## Peppertree Quarry Modification 5

# ENVIRONMENTAL ASSESSMENT PRELIMINARY RESPONSE TO SUBMISSIONS

## MODIFICATION 5 ENVIRONMENTAL ASSESSMENT | PRELIMINARY RESPONSE TO SUBMISSIONS REPORT

Prepared for Boral Resources (NSW) Pty Limited  
January 2019

Figure 1

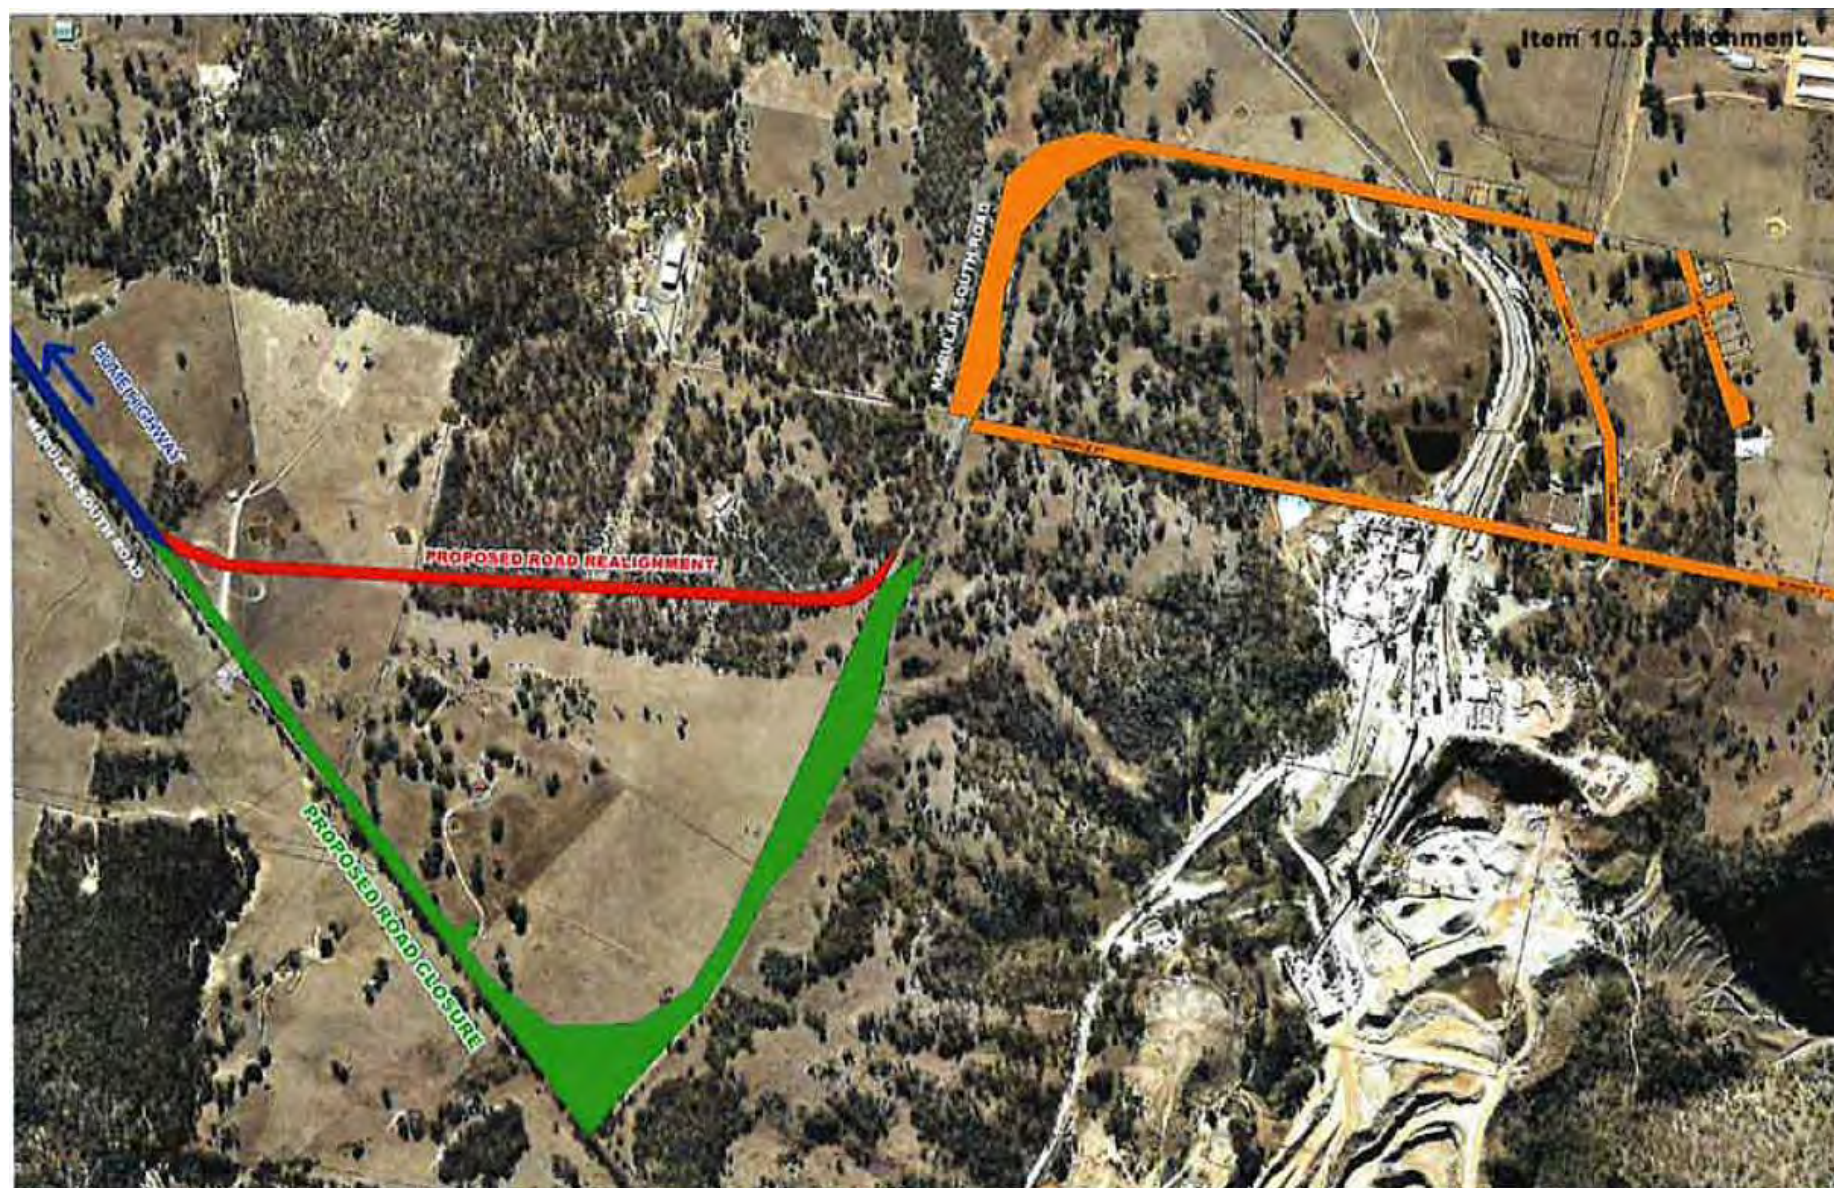
**Council is currently negotiating with Boral in relation to the closure and purchase of Council roads within the site (refer Attached, Figure 1). It is recommended that prior to works commencing, all road closure requirements and works are to be finalised.**

Council is currently negotiating with Boral in relation to the closure and purchase of Council roads within the site (refer Attached, Figure 1).

Figure 2

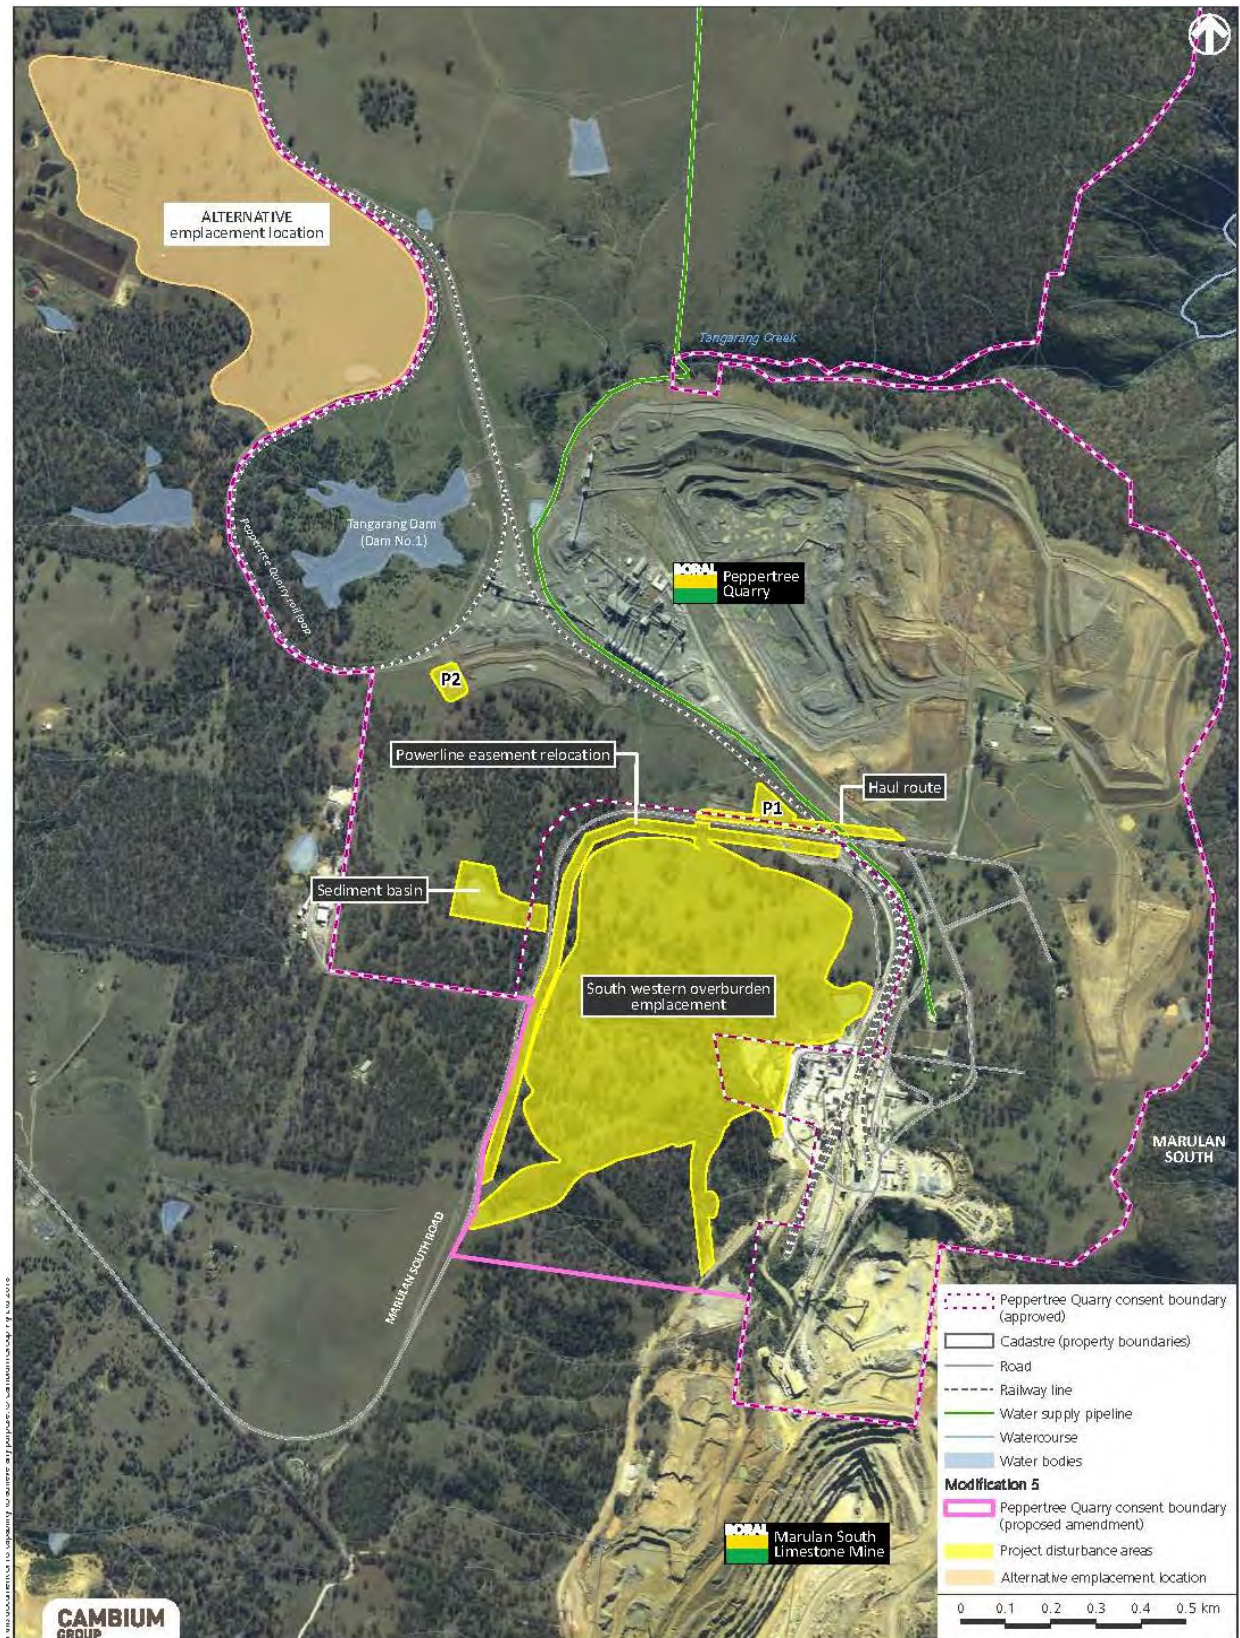
**If the road closure permits are not finalised before this road is operational the haul road will conflict with a public road (Refer Attached, Figure 2).**

If the road closure permits are not finalised before this road is operational the haul road will conflict with a public road (Refer Attached, Figure 2).

Figure 7  
The Project

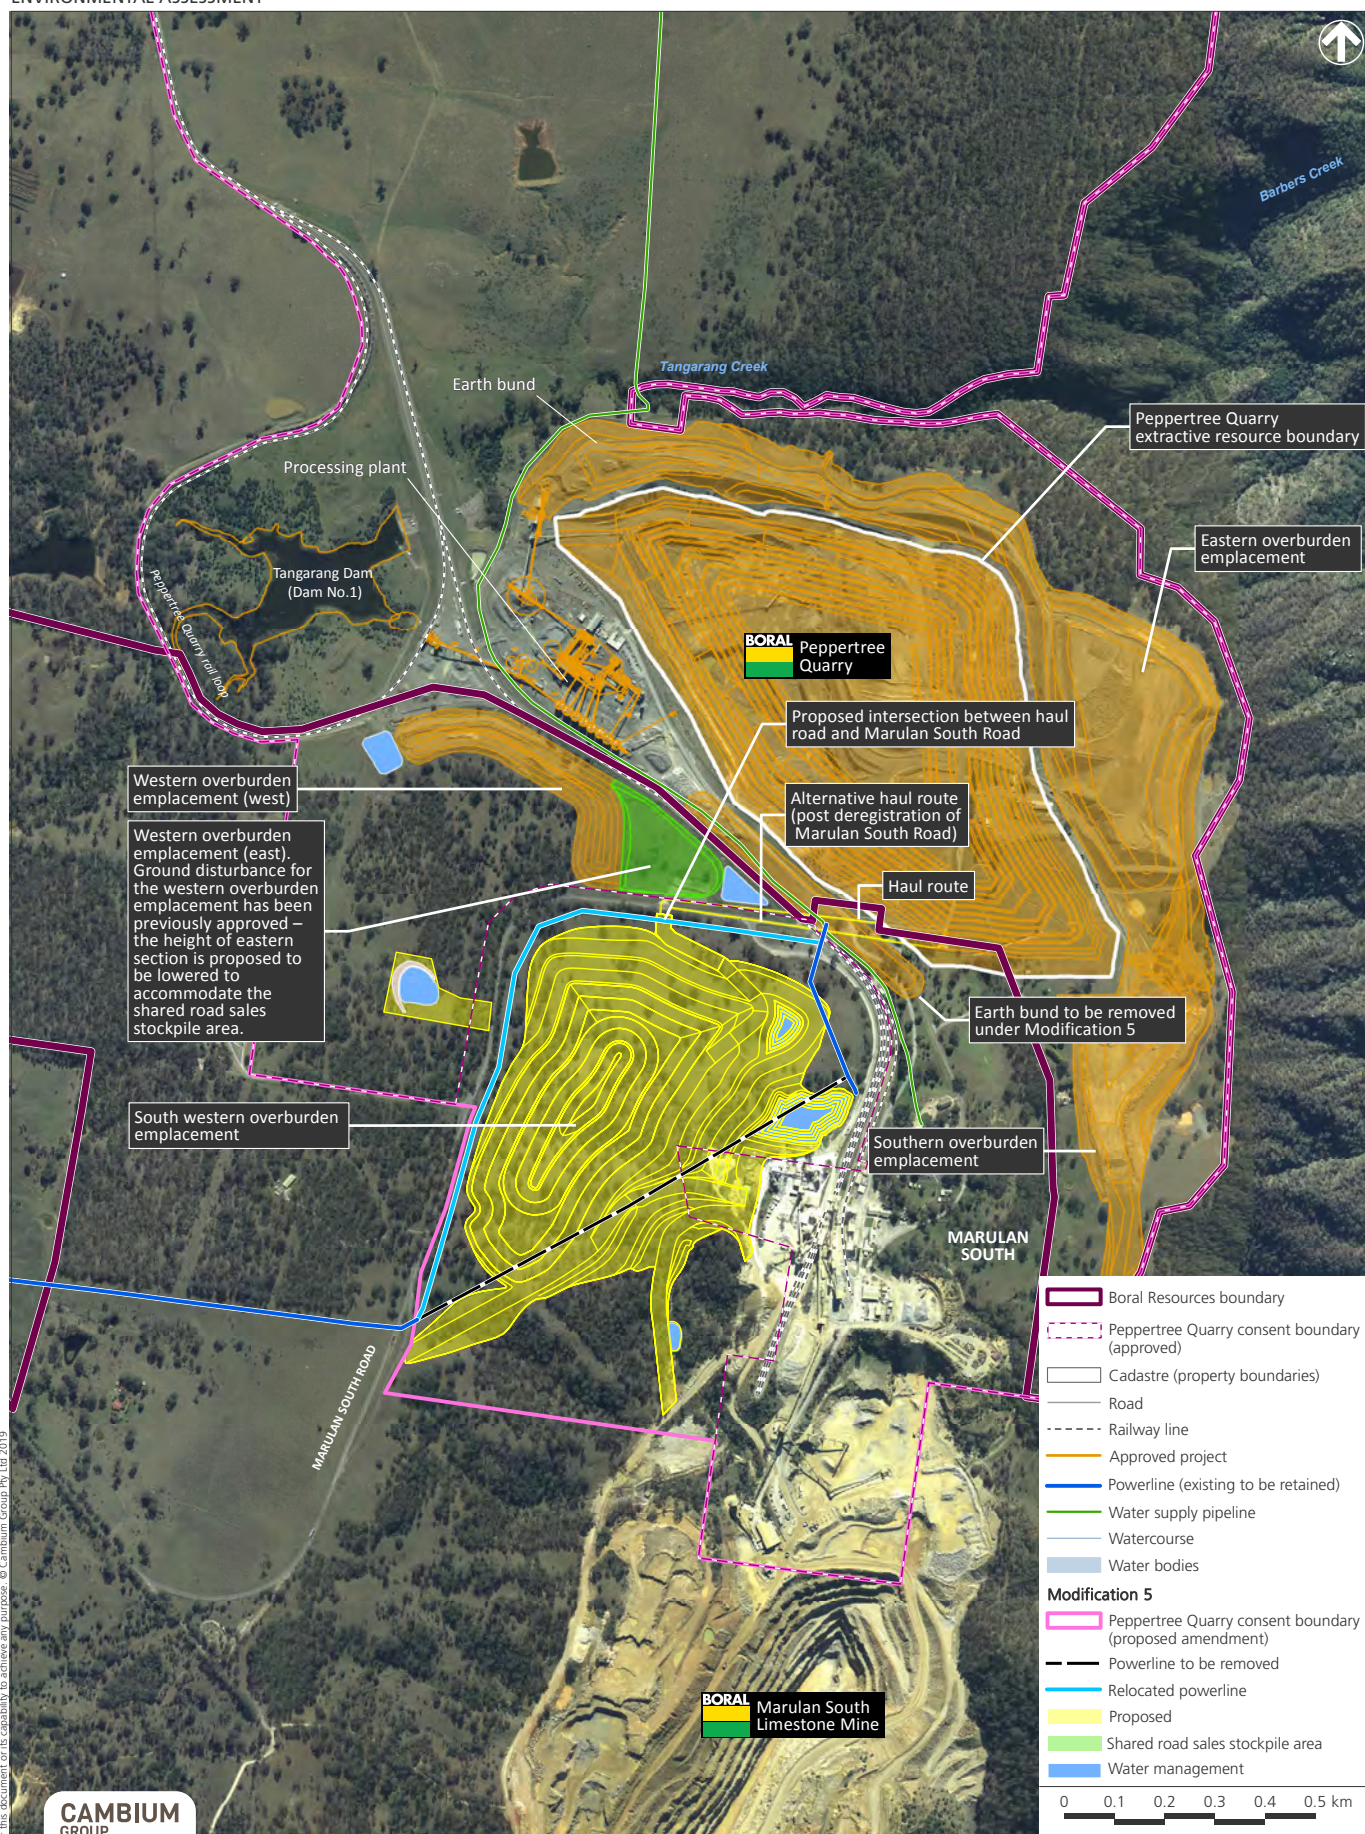
**Provide a map which clearly delineates the positioning of the proposed intersection scenarios.**

A plan has been prepared by Cambium showing the location of the alternate intersection location (Appendix E).
